S. Bellaire
File No: SP12-012179

TO:	CHAIR AND MEMBERS PLANNING AND ENVIROMENT COMMITTEE MEETING
FROM:	GEORGE KOTSIFAS, P.ENG. MANAGING DIRECTOR, DEVELOPMENT AND COMPLIANCE SERVICES AND CHIEF BUILDING OFFICIAL
SUBJECT:	APPLICATION BY: ZELINKA PRIAMO LTD. 1235-1253 RICHMOND STREET PUBLIC SITE PLAN MEETING JANUARY 8, 2013 AFTER 4:45PM

The purpose of this application is to obtain Site Plan Approval for a new 19 storey apartment building with 311 two bedroom units located at 1235-1253 Richmond St. The application for site plan approval has been made to ensure the development takes a form compatible with adjacent land uses.

Proposed Landscape Plan

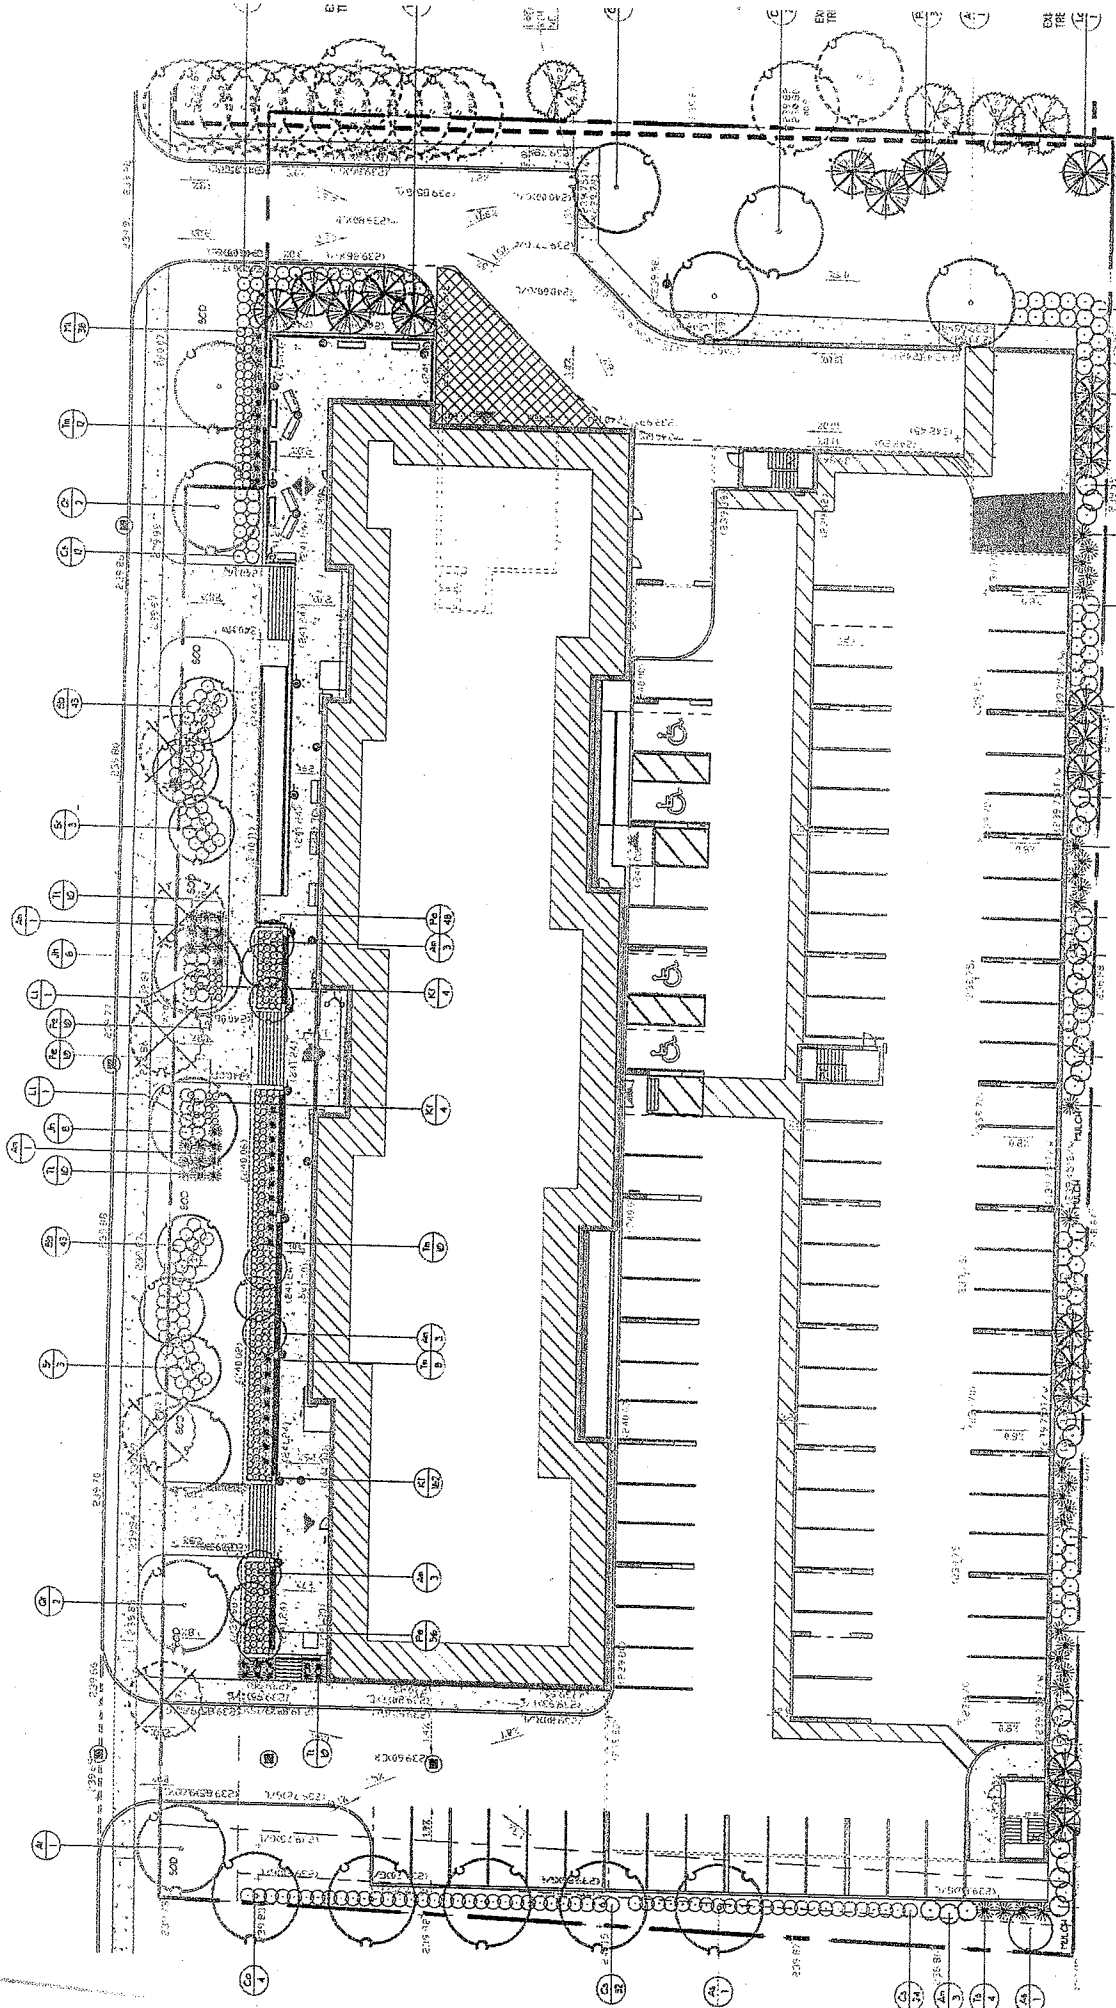
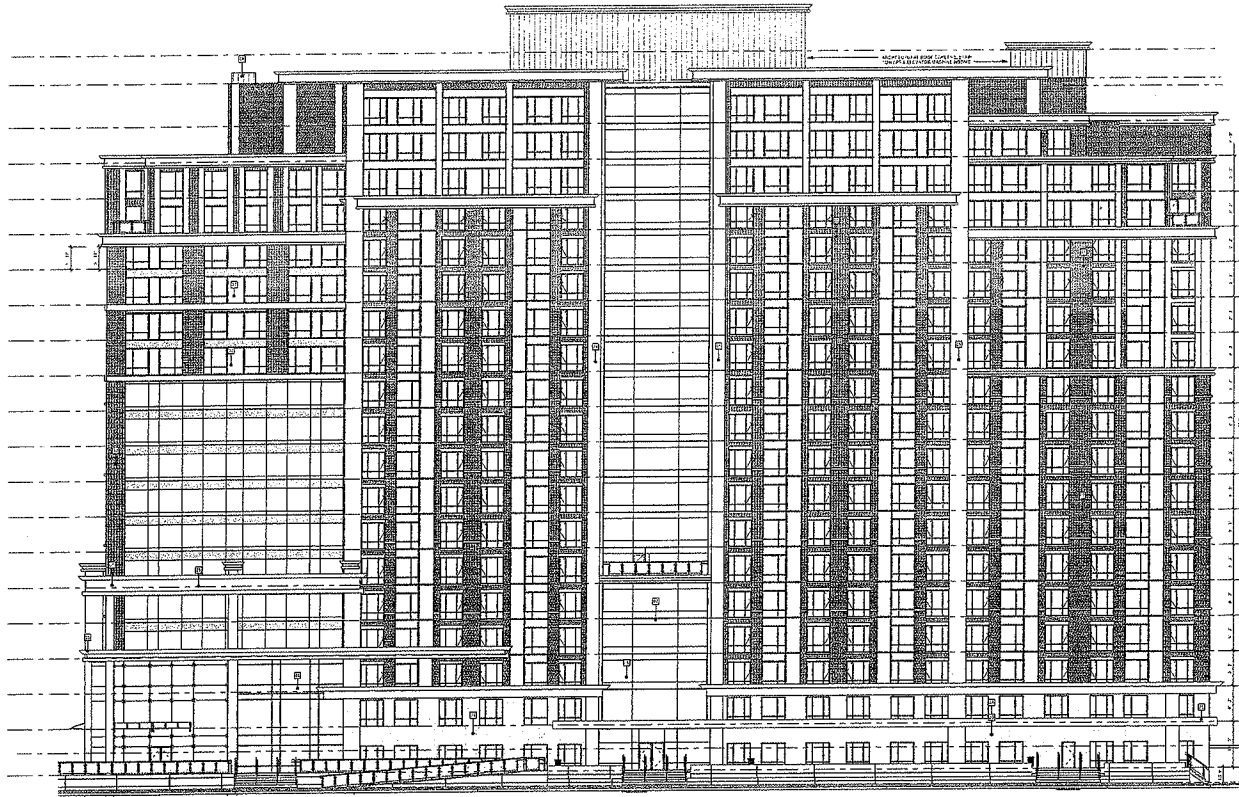
- Include landscaping along Richmond Street where the retaining wall does not have proposed planters. This includes in front of the ramp and portion where the elevated patio is proposed.

The landscape plan incorporates a paved and landscape urban forecourt along Richmond Street along with proposing trees and shrubs within the City's road widening allowance. Plant material has been placed on the edges of the property to help soften the interface of the development with the surrounding buildings. In order to comply with the Bonusing intent of the Zoning By-law, landscape material is required to be planted along Richmond Street where the retaining wall does not have proposed planters.

The landscape plans incorporates a paved and landscape urban forecourt along Richmond Street within the subject property limits. The forecourt has incorporated fixed and moveable seating, planter boxes and lighting standards along with plant material to accomplish this design feature. Landscape plant material has been requested where the retaining wall does not have proposed planters along Richmond Street.

Proposed North Elevation Facing Richmond Street

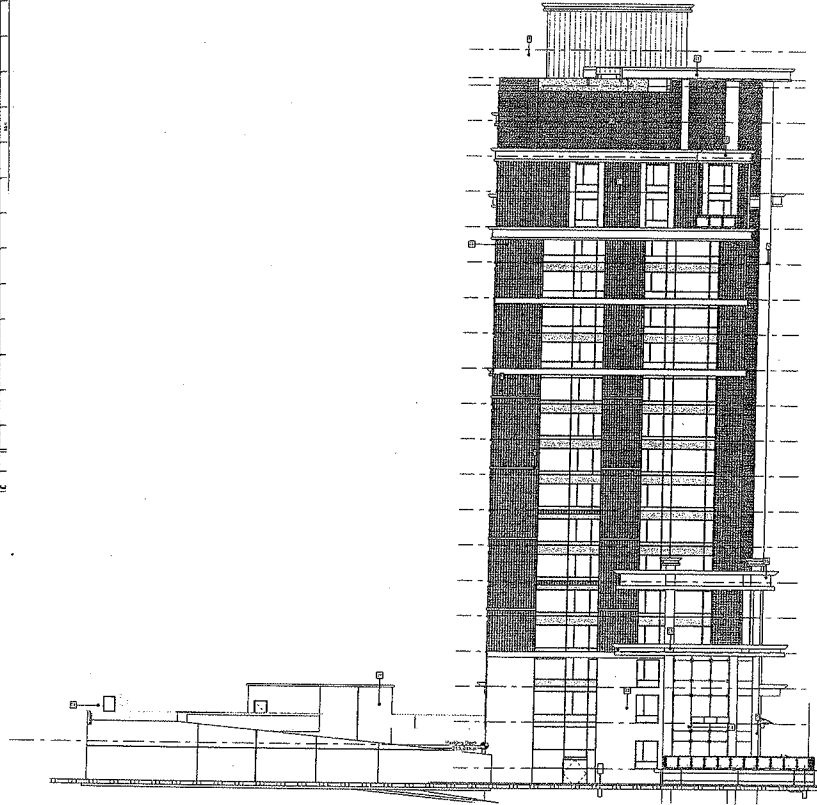
- The brick portion in front of the mechanical penthouse is no longer shown on the North Elevation. It is important that the roofline includes the brick portion in order to better integrate the penthouse into general design of the building. The South Elevation of the penthouse should also be redesigned to better integrate with the South Elevation of the building.

Proposed South Elevation

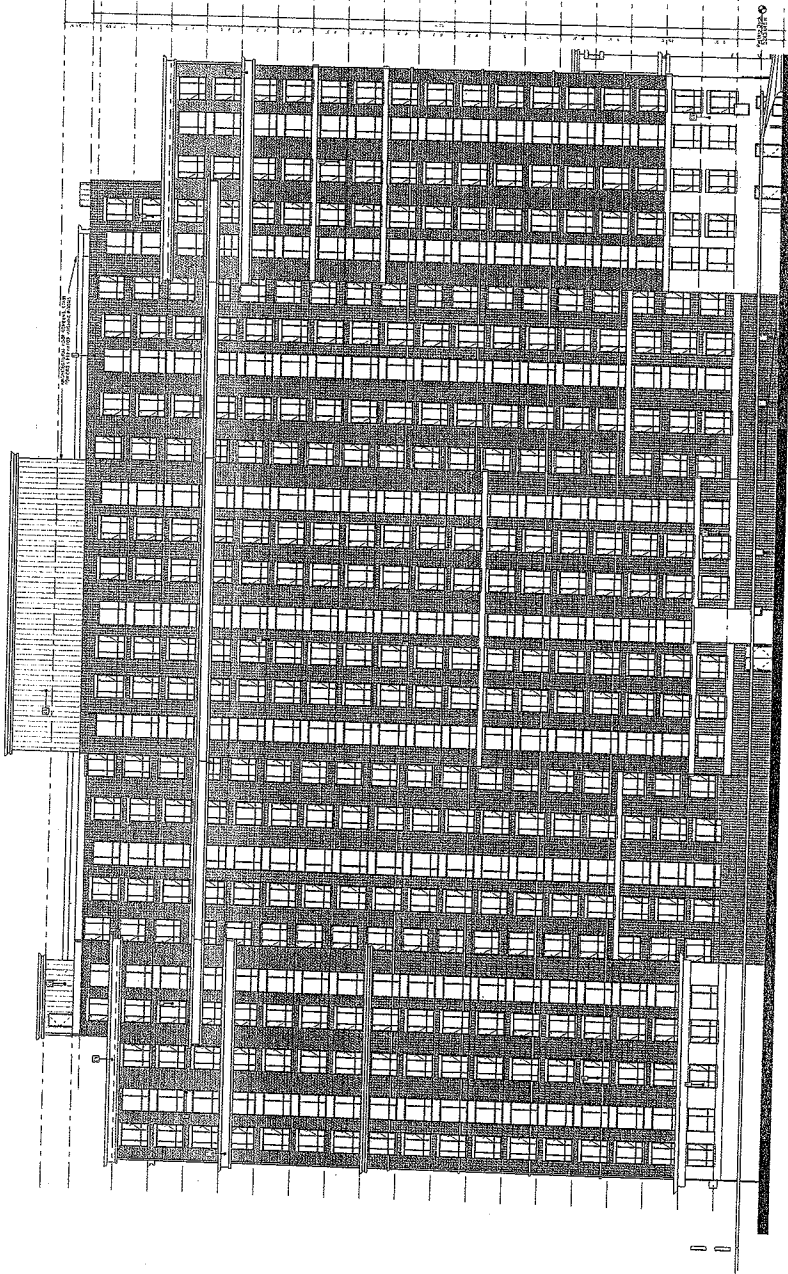
- Further break up the South Elevation by including changes in material type and/or colour. This is important as the rear of the building is highly visible from the Thames River Corridor and the design of the South Elevation should take into consideration its interface with the corridor. In 2010, Council approved the Thames River Corridor Plan that requires appropriate integration of new buildings into the corridor environment rather than “turning their back” to the corridor. One possible solution is to change the material or colour of material on the two portions of the building that are recessed from the rest of the facade.
